ADDENDUM NUMBER 1 ON INVITATION TO BID ITB18KO-129

TITLE: Beaty East – Clean, Point and Seal

BEATY - SOUTH ELEVATION

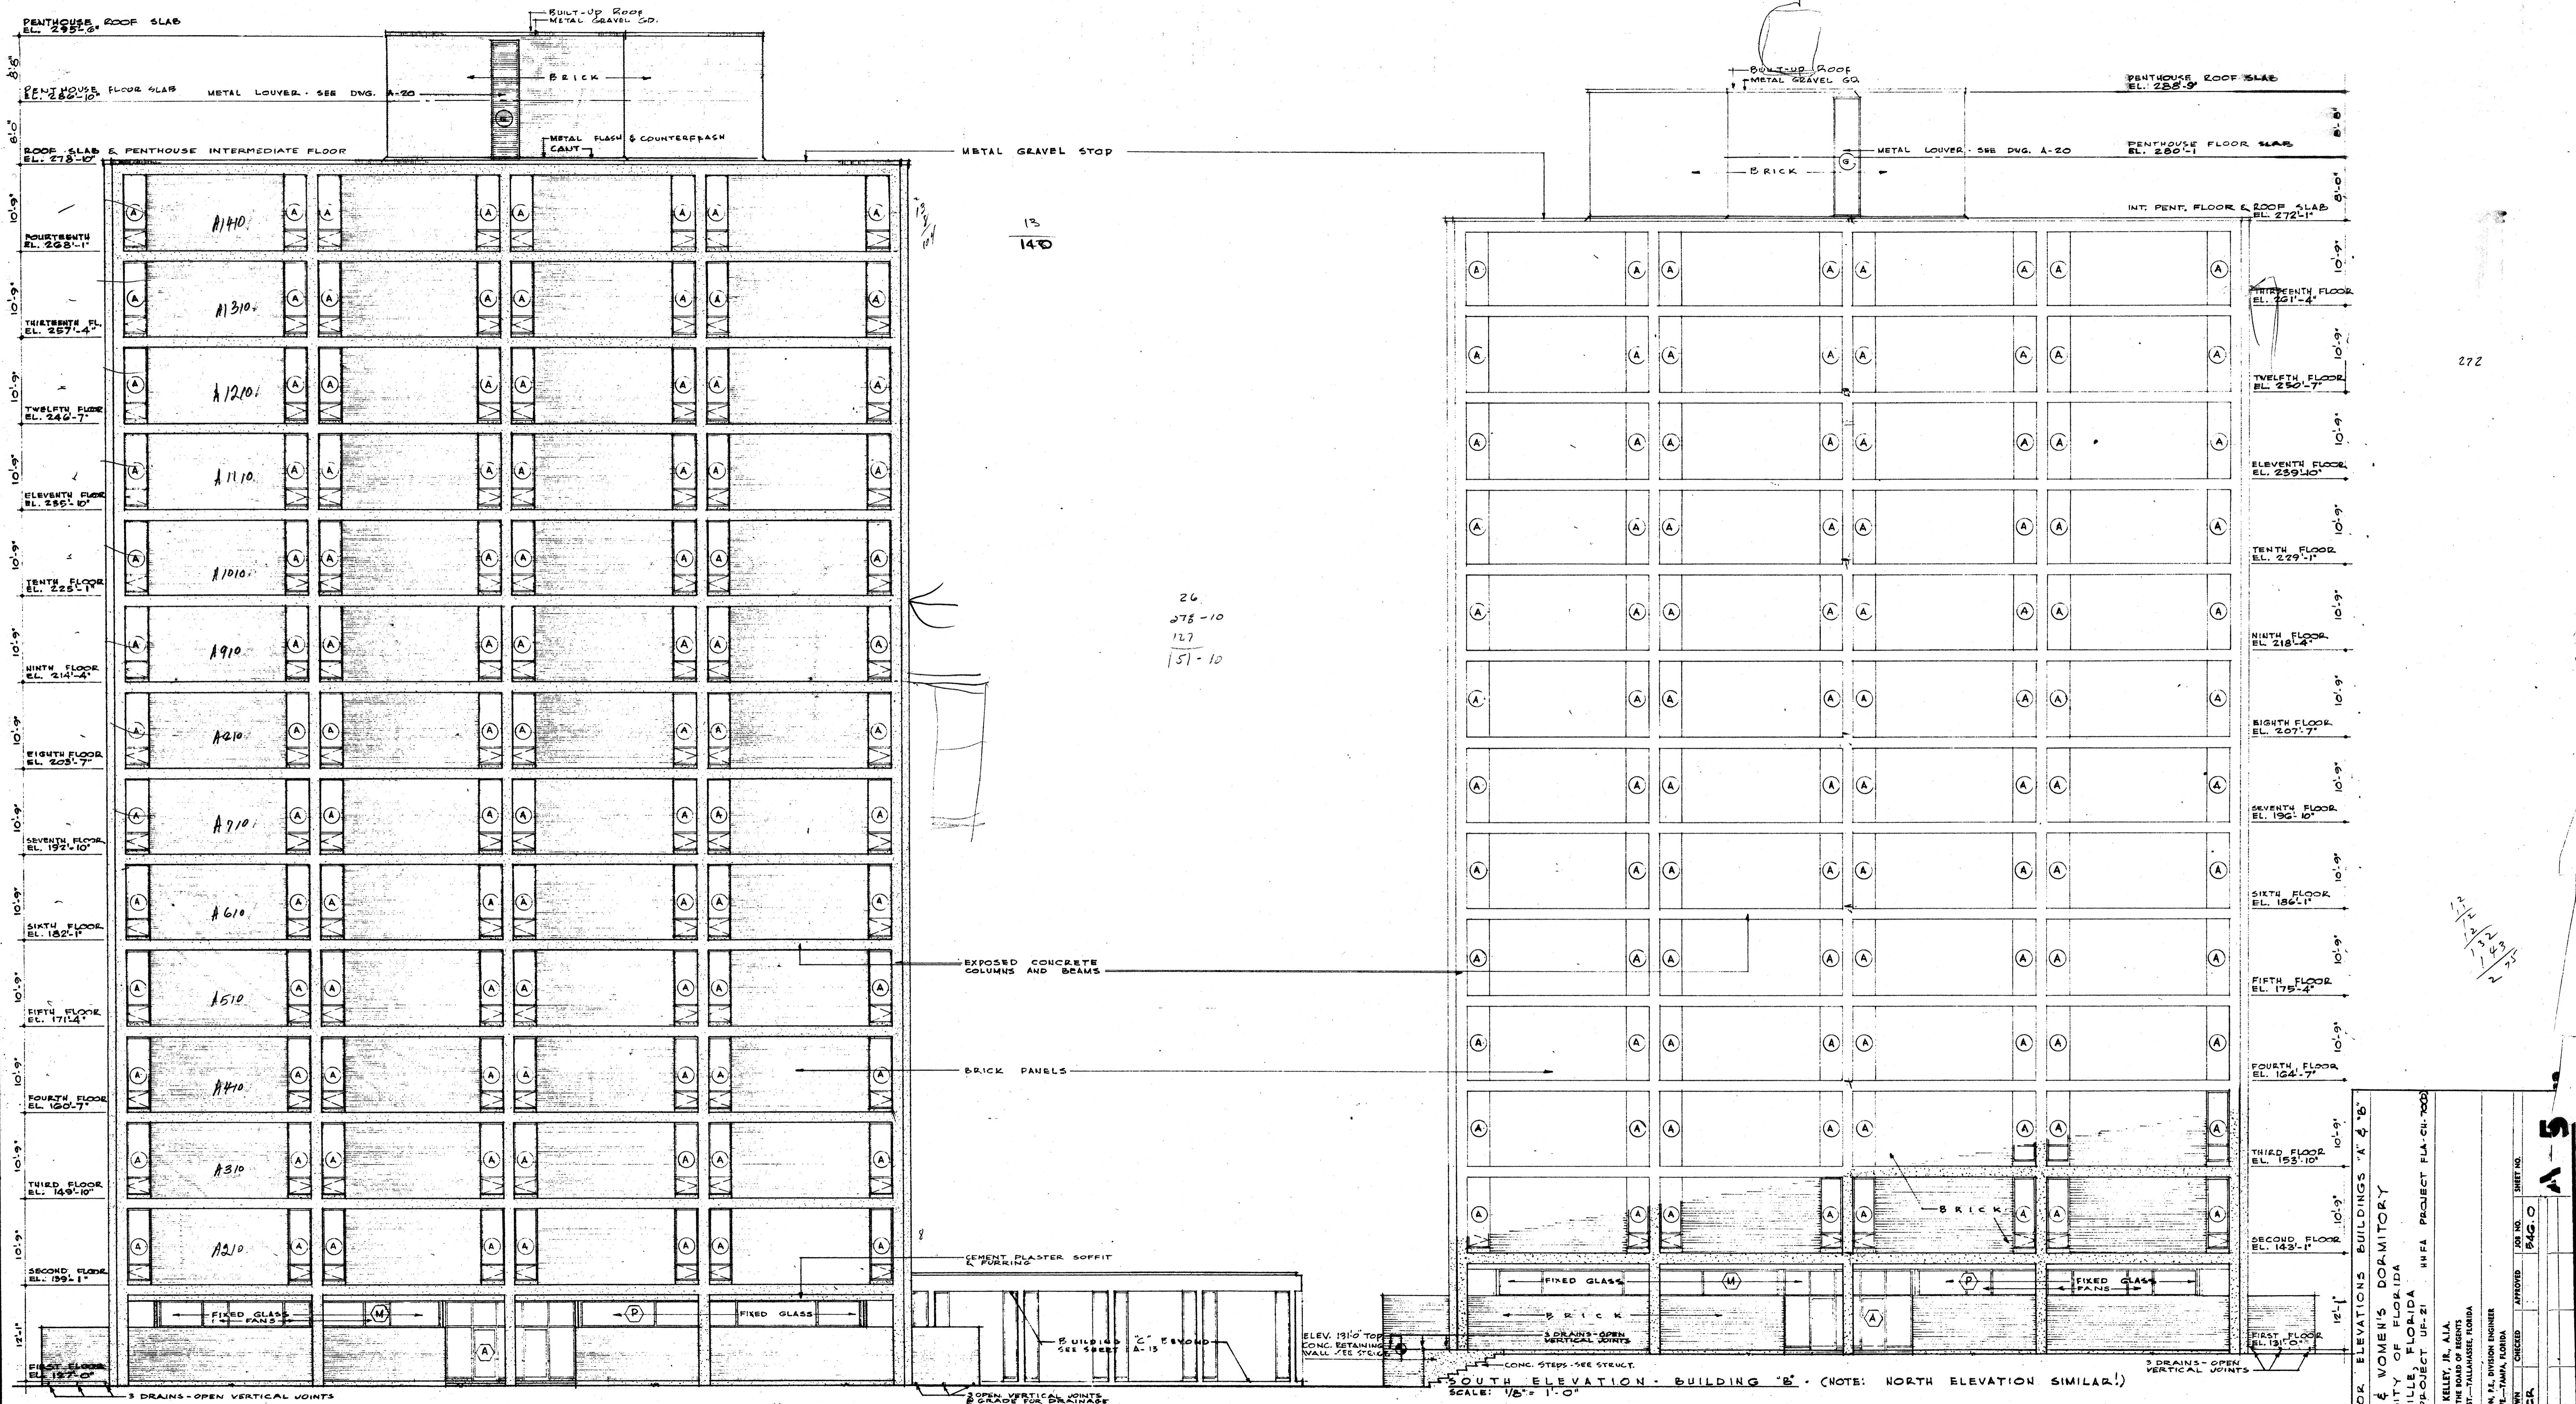
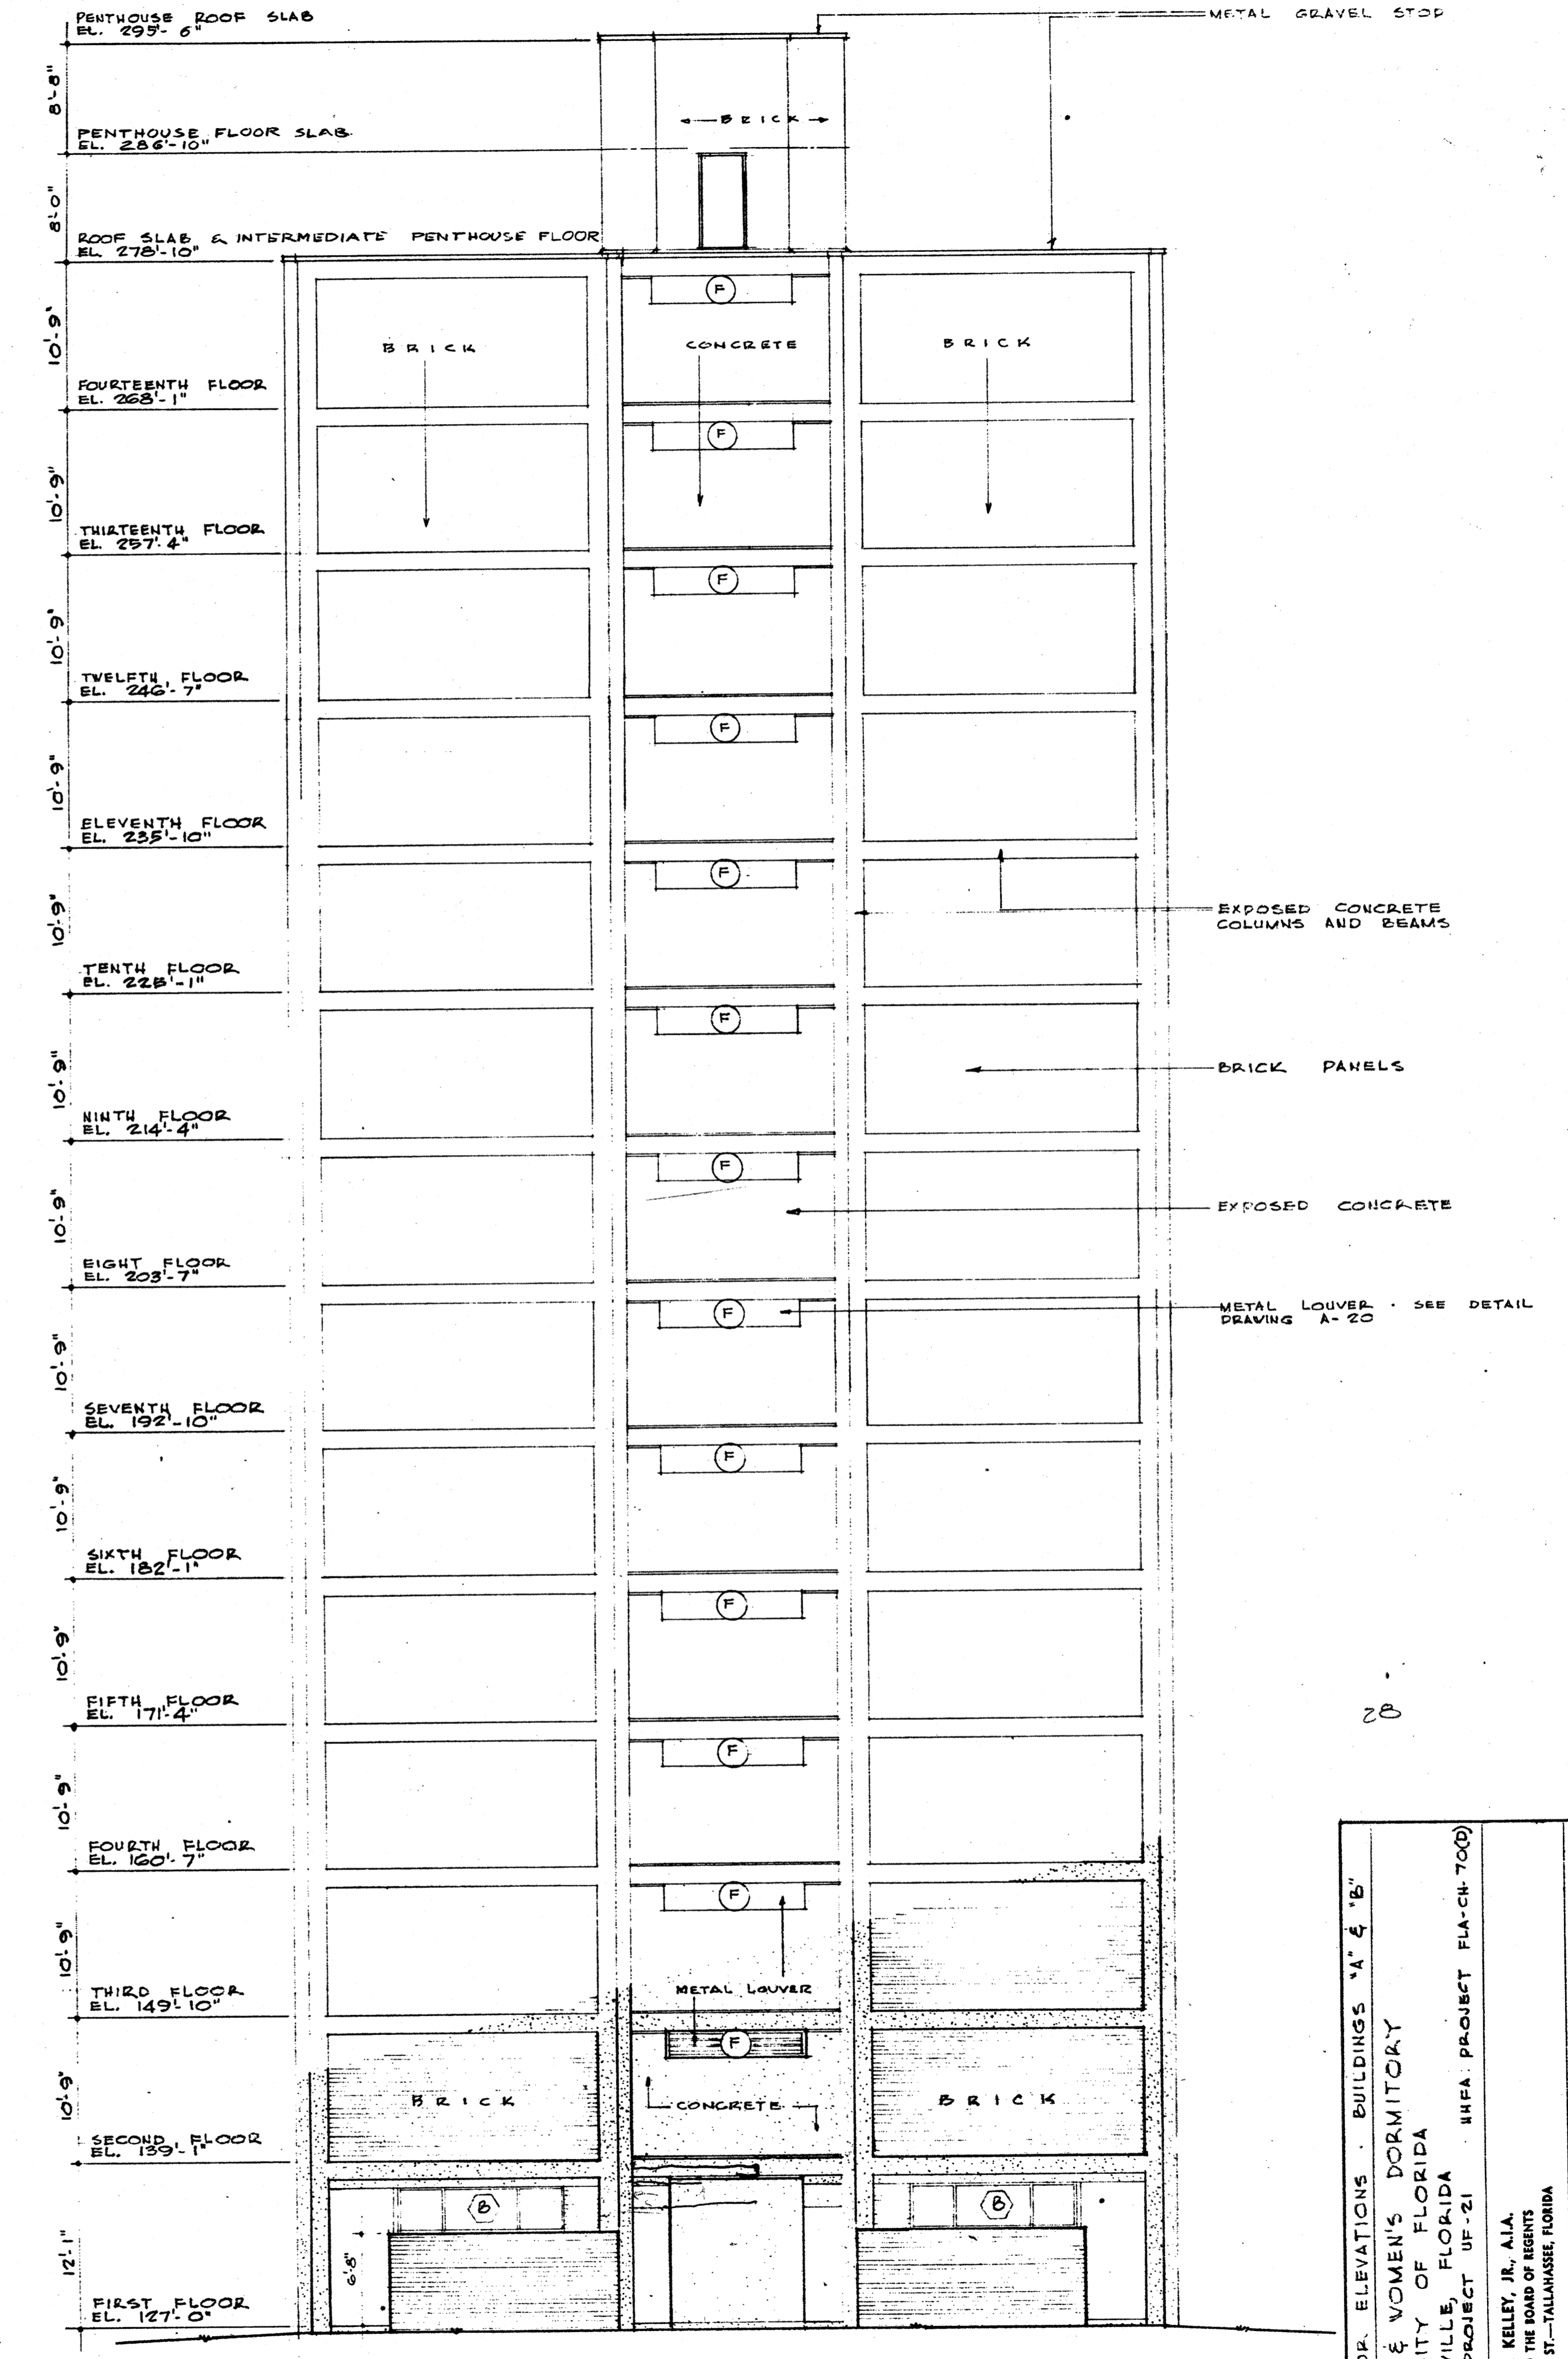
A12. North side - 600 square foot (include in base bid). South side - 600 square foot (include in base bid). East side - 300 square foot (include in Alternate 1). West side - 300 square foot (include in Alternate 2). Include a price per square foot for concrete beams and columns beyond what is included in the base bid. See revised Section 00310 – Price Page included in this Addendum.

A13. North side - 6000 lineal foot (include in base bid). South side - 6000 lineal foot (include in base bid). East side - 3000 lineal foot (include in Alternate 1). West side - 3000 lineal foot (include in Alternate 2). Include a price per lineal foot for point and tuck beyond what is included in the base bid. See revised Section 00310 – Price Page included in this Addendum.
